MATHIS BAY ESTATES SUBDIVISION

Revised for the March 5th meeting:

APPLICATION NUMBER 6 DATE March 5, 2015

MATHIS BAY ESTATES SUBDIVISION

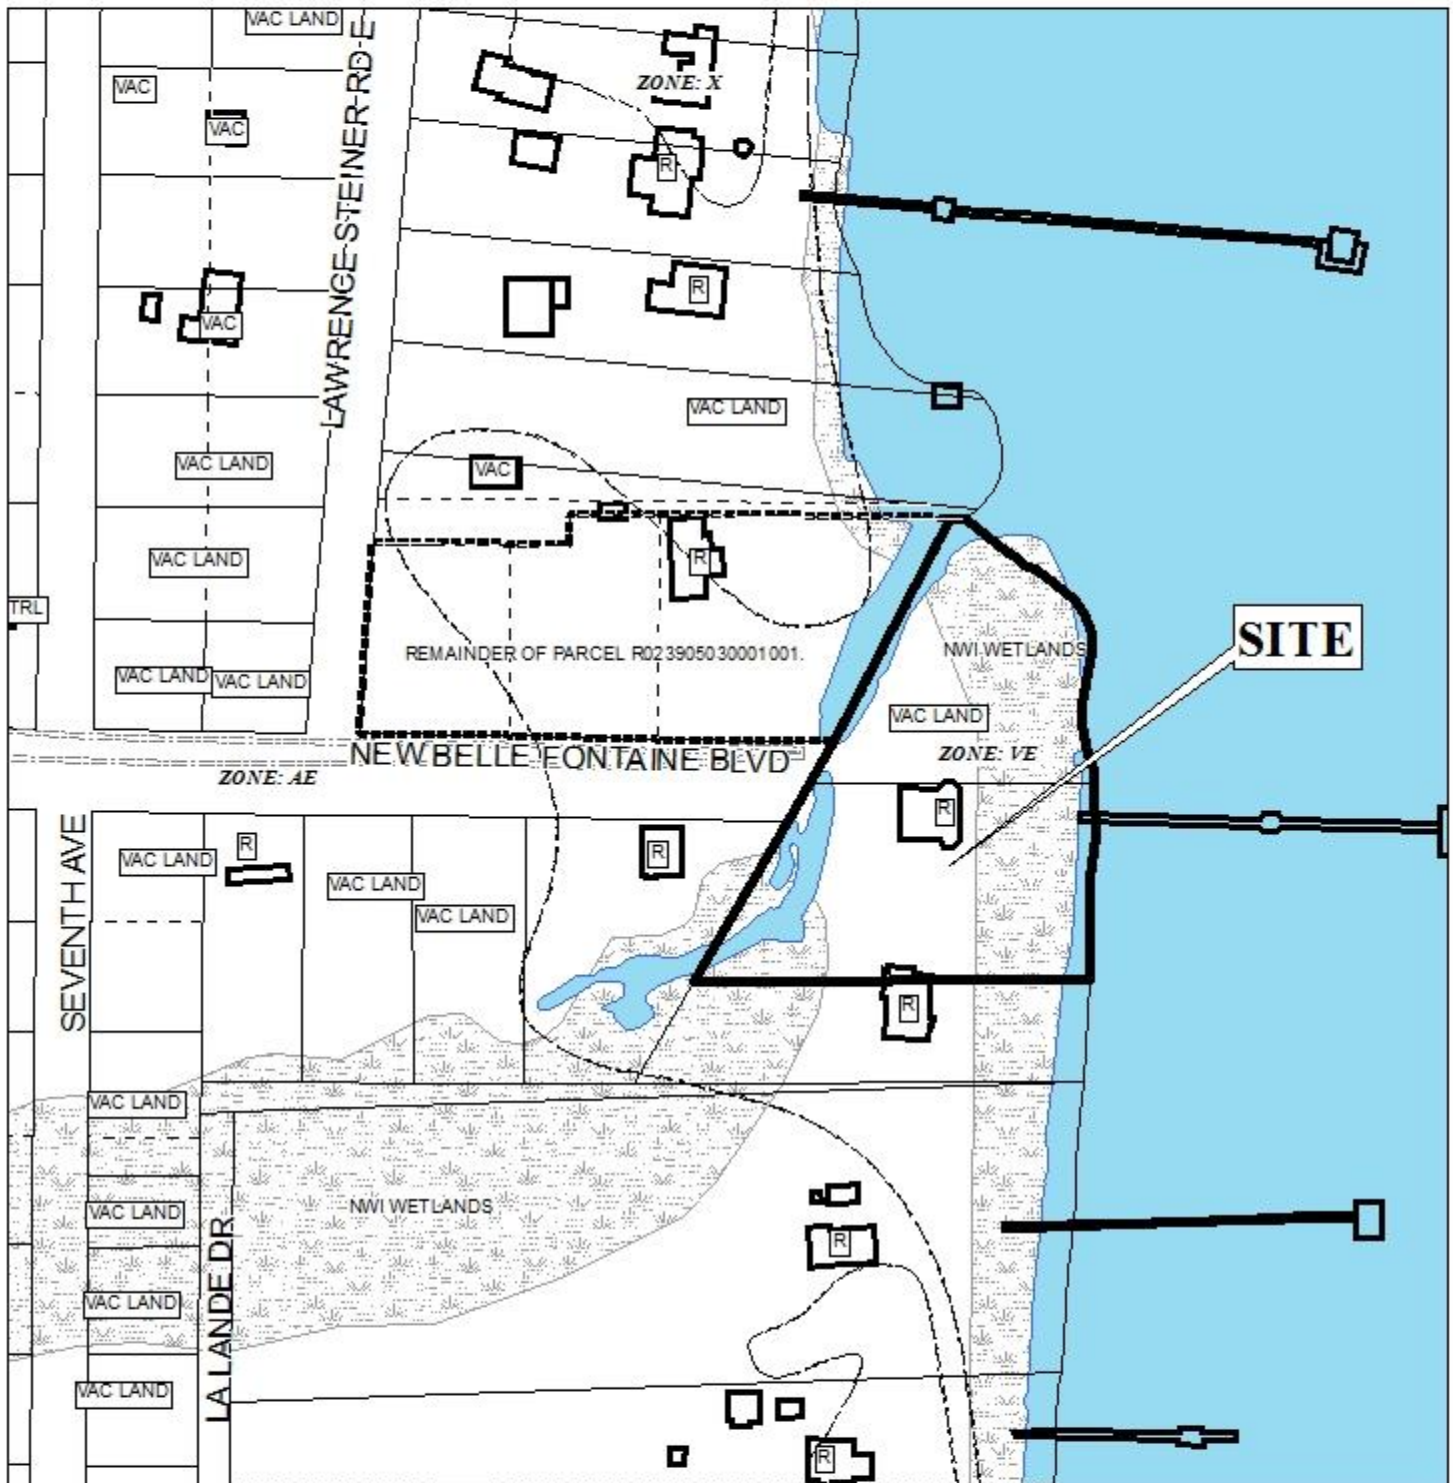
The plat illustrates the proposed 3-lot, 2.0± acre subdivision located at the East terminus of New Bellefontaine Boulevard, within the Planning Jurisdiction. The applicant states that the subdivision is served by public water and individual septic tank services.

The plat indicates a 25' building setback line for all lots and this should also be shown on the Final Plat, if approved. All lots meet the minimum size requirements of the Subdivision Regulations and are labeled with their sizes in both square feet and acres on the preliminary plat. If approved, the Final Plat should retain these size labels, or a table should be furnished on the Final Plat providing the same information.

There are existing and proposed easements within the site; therefore, if approved, a note should be required on the Final Plat stating that no structures are to be constructed within any easement.

Lots 2 and 3 would be flag lots which are generally discouraged by Section V.D.1. of the Subdivision Regulations. However, they are permitted only in instances of family subdivisions or in those locations where varied and irregularly-shaped lot designs are common and the informality of design is consistent with other lots in the vicinity. There have been other flag lot

subdivisions allowed by the Commission within the vicinity and this particular subdivision would be similar. Therefore, a waiver of Section V.D.1. of the Subdivision Regulations would be in order, if approved. A note should be required on the Final Plat stating that no further resubdivision of any lot is allowed until additional public street frontage is provided.

No Flood Zone data was given on the preliminary plat. However, GIS data indicates the site to be within the VE Flood Zone. The presence of a floodplain indicates that the area may be environmentally sensitive; therefore, the approval of all applicable federal, state and local agencies would be required prior to the issuance of any permits or land disturbance activities.

It should be noted that when the two subject lots were created via the Resubdivision of Lot 302 and a Portion of Lot 301, Gray's Belle Fontaine Shores Subdivision, a note was placed on the Final Plat specifically stating that Lots 2 and 3 will not be resubdivided unless additional frontage and access is provided. New Bellefontaine Boulevard was indicated with a 75' right-of-way width for that Subdivision, the same as for the current. No additional frontage or access is now provided, and no justification for the non-adherence to that note is given.

With a waiver of Section V.D.1., the plat would ordinarily meet the minimum requirements of the Subdivision Regulations and be recommended for tentative approval. However, this particular Subdivision must be recommended for denial for the following reasons:

- 1) the subject site is restricted from further resubdivision by the note on the recorded plat of the Resubdivision of Lot 302 and a Portion of Lot 301, Gray's Belle Fontaine Shores Subdivision stating such; and
- 2) no justification for the non-adherence to that restriction was provided.

Therefore, staff recommends that this application must be denied for the following reasons:

- 1) the subject site is restricted from further resubdivision by a note on the recorded plat of the Resubdivision of Lot 302 and a Portion of Lot 301, Gray's Belle Fontaine Shores Subdivision stating such;*
- 2) no justification for the non-adherence to that restriction was provided; and*
- 3) no additional frontage is being provided.*
